UNITED STATES  
NUCLEAR REGULATORY COMMISSION

**FACILITIES:** Calvert Cliffs Nuclear Power Plant, (CCNPP) Unit Nos. 1 and 2

**SUBJECT:** SUMMARY OF OCTOBER 12, 1999, MEETING WITH BGE REGARDING  
LICENSE RENEWAL ACTIVITIES FOR CCNPP UNIT NOS. 1 AND 2

REACTOR VESSEL NO. 11  
LEAKAGE MONITOR TUBE  
(N. T. S.)

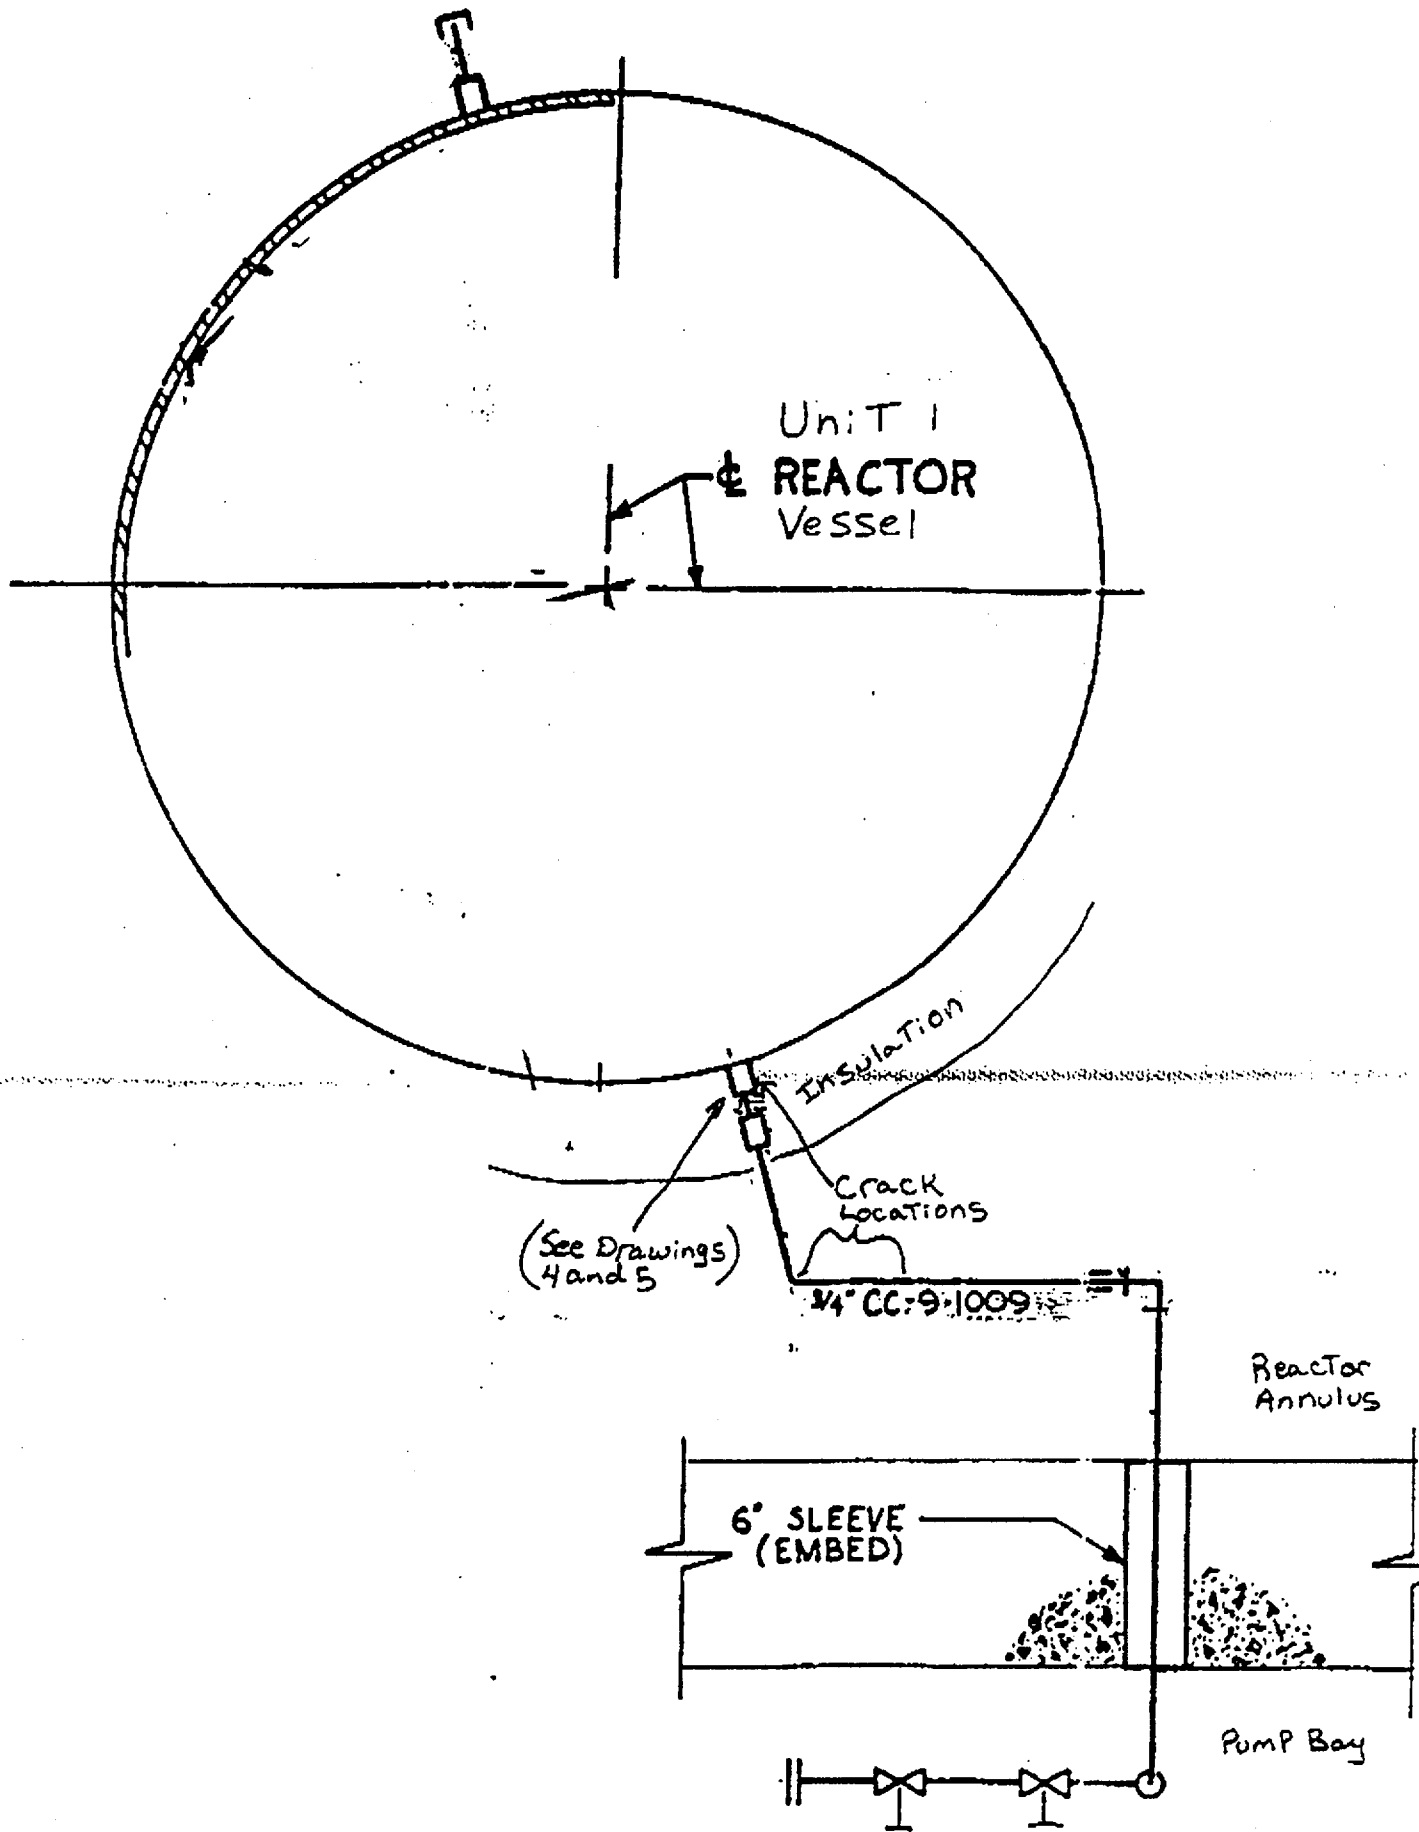
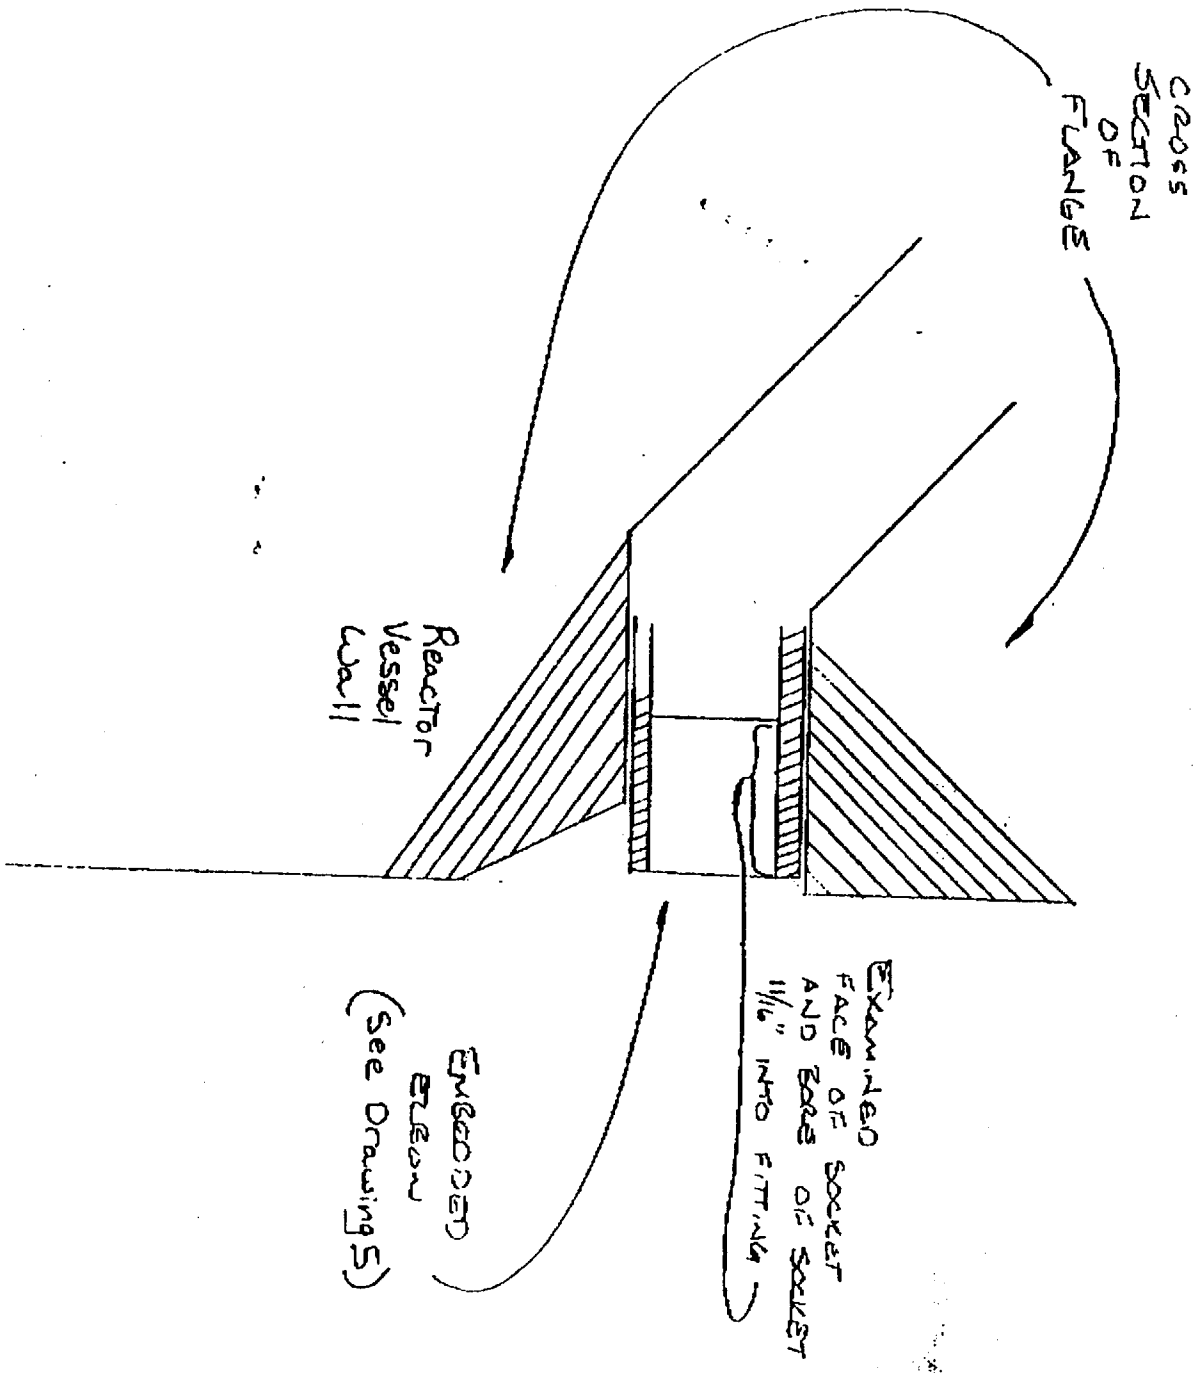
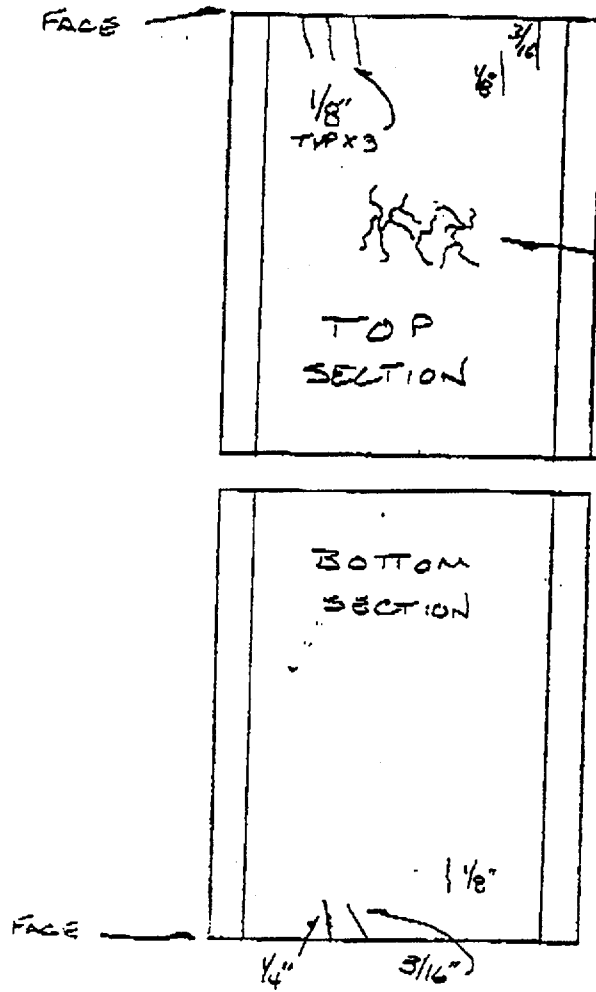
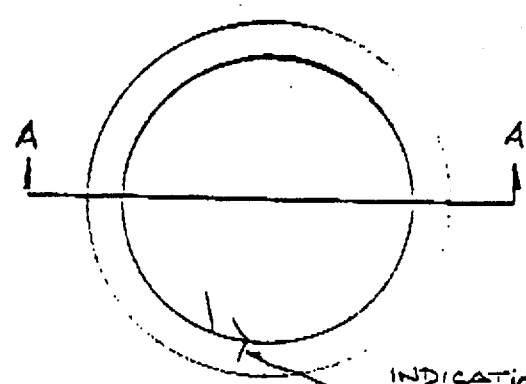
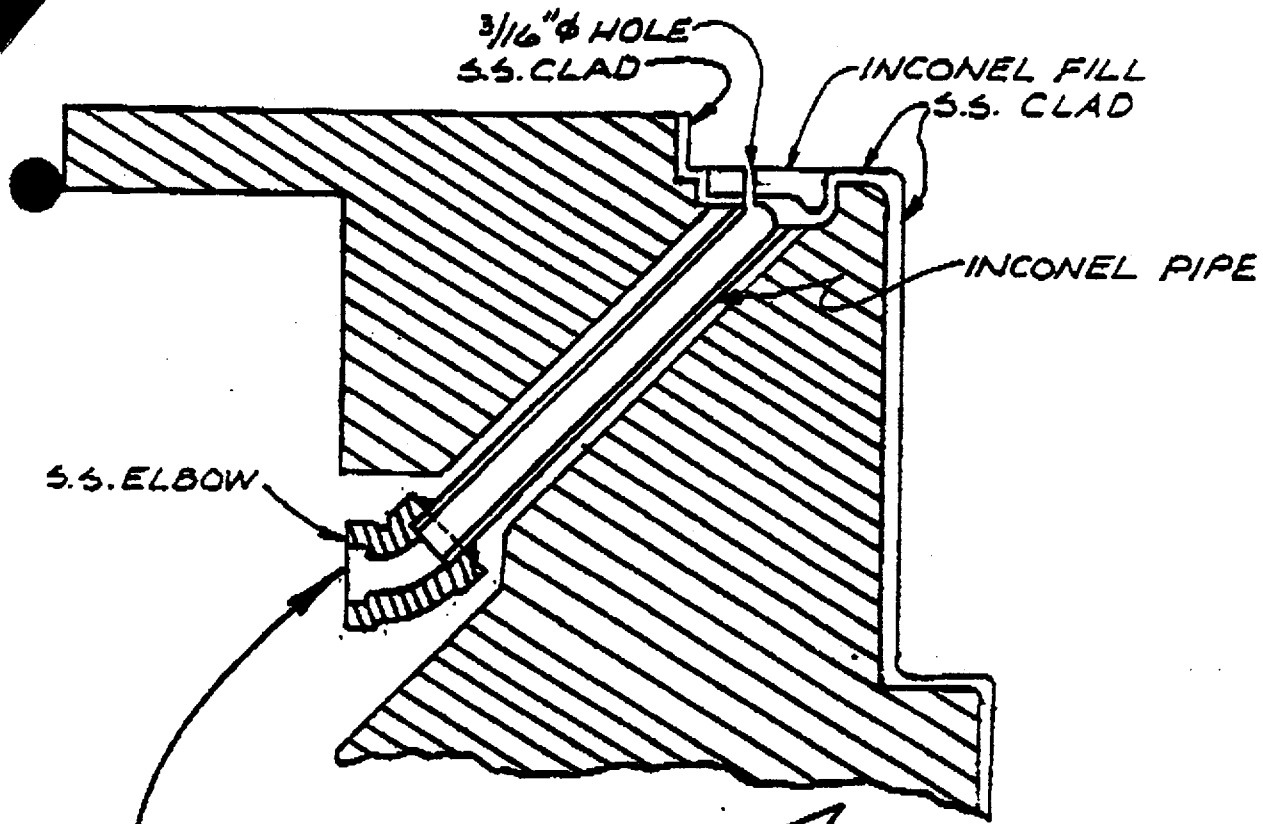
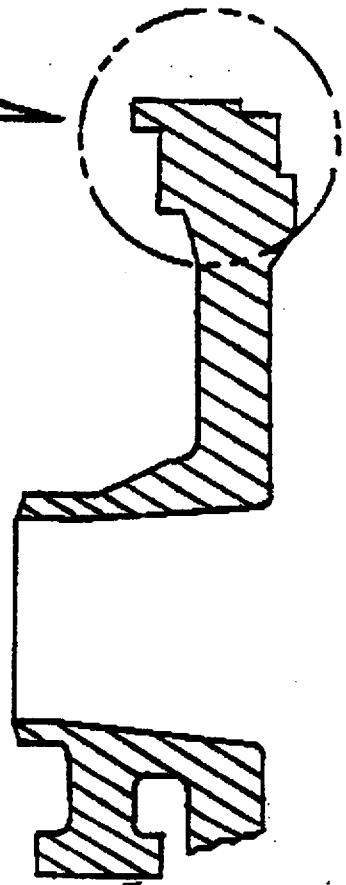
Proposed response to OI 3.2.3.2.1-2 (Vessel Flange Leak Off Line)

Chloride Ion Stress Corrosion Cracking (CISCC) of the Reactor Vessel o-ring leak-off pipe was caused by elevated levels of chlorides in the pipe. The chlorides in Refueling Pool water trapped in the pipe following Reactor Vessel head installation can become concentrated on the inside of the pipe by boiling of the water during plant operation. The high chloride source may have been present inside of the pipe since initial plant construction.

Maintenance procedure RV-78 (Reactor Vessel Closure Head Installation) was modified to require draining the leak detection piping and drying it with compressed air after the Refueling Pool is drained.

The Reactor Vessel is insulated; the o-ring leak-off pipe is not insulated. The failed section of piping was in a long run attached to the elbow just beyond the Reactor Vessel insulation. The temperature of RCS water on the inside of the Reactor Vessel at the elevation of the leak-off pipe penetration is between 548 and 595 °F; the temperature of the insulated vessel wall pipe nozzle is expected to be in the same temperature range. The air temperature outside of the Reactor Vessel, in the area of the uninsulated leak-off piping, is a maximum 170°F (Bechtel calculation sheet, job #9379, for cavity cooling temperatures).

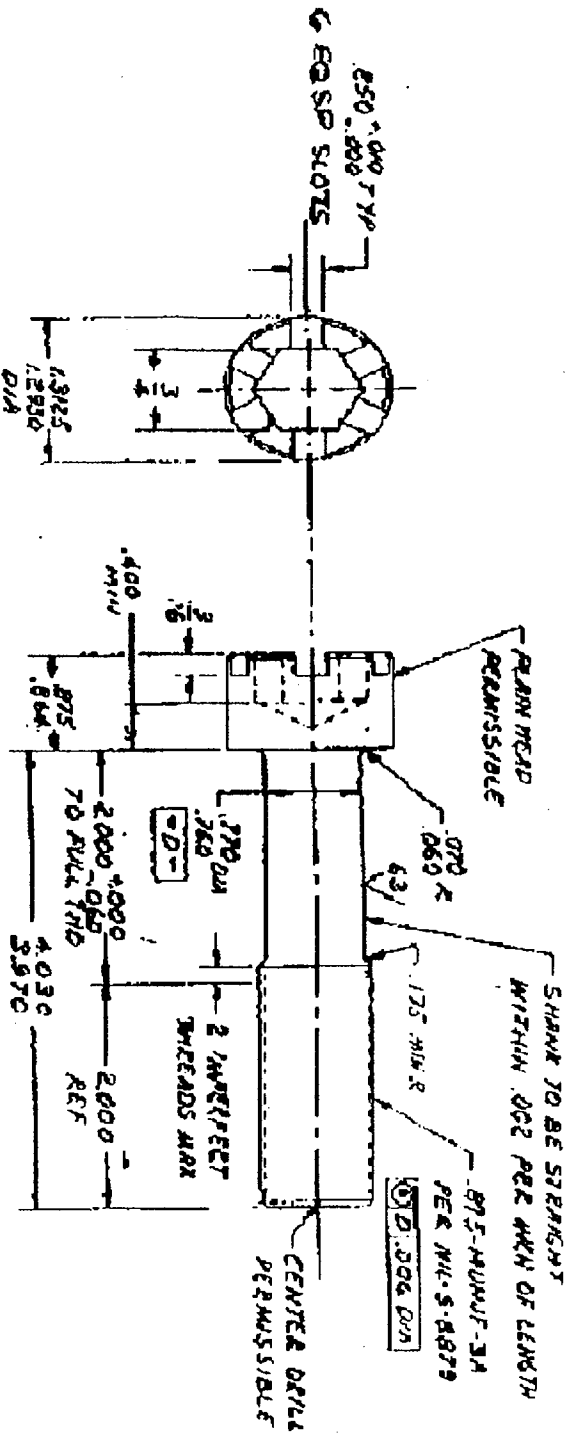
BGE agrees that the use of the word 'random' in BGE letter of 7/2/99 implies an assumption. However, BGE did not make that assumption of random versus localized failures in concluding that the aging management approach described provides reasonable assurance that the function of the CEA shroud will be maintained. BGE agrees with what appears to be an NRC assumption that these failures would not necessarily be random, and BGE apologizes for the confusion.

The only failure of these bolts that would affect an individual bolt's lateral support and alignment function would be a crack across the interface plane between the CEA Shroud and the Fuel Assembly Alignment Plate. However, the geometry of the bolts is such that, should a failure occur, it is not likely to occur at that interface. A diagram of the bolt is shown below. Based on the geometry shown, experience with actual failures of similar bolts in different applications, and the fact that the threads are rolled, BGE believes areas likely to fail are areas such as the transition between the bolt head and the shank, the transition between the shank and the threaded area, and the shank itself.

These bolts are inserted from the bottom up. The diagram below does not show the interface plane, but it is in the threaded region of the bolt. This means that if a bolt fails below the interface plane (towards the head), the portion above the failure will provide the lateral support and alignment function, and if the bolt fails above the interface plane, the lower part of the bolt would still be threaded and would maintain the function.

More than three (or more than six for a dual shroud) bolts would have to fail at the interface plane to put the plant in an unanalyzed condition. Entry into such a condition is highly unlikely due to the most likely failure mechanism and its relationship to the critical function, as described above. Undetected entry into such a condition is even more unlikely since bolt failures in the unthreaded portion would eventually be detected when bolt locking tabs break free.
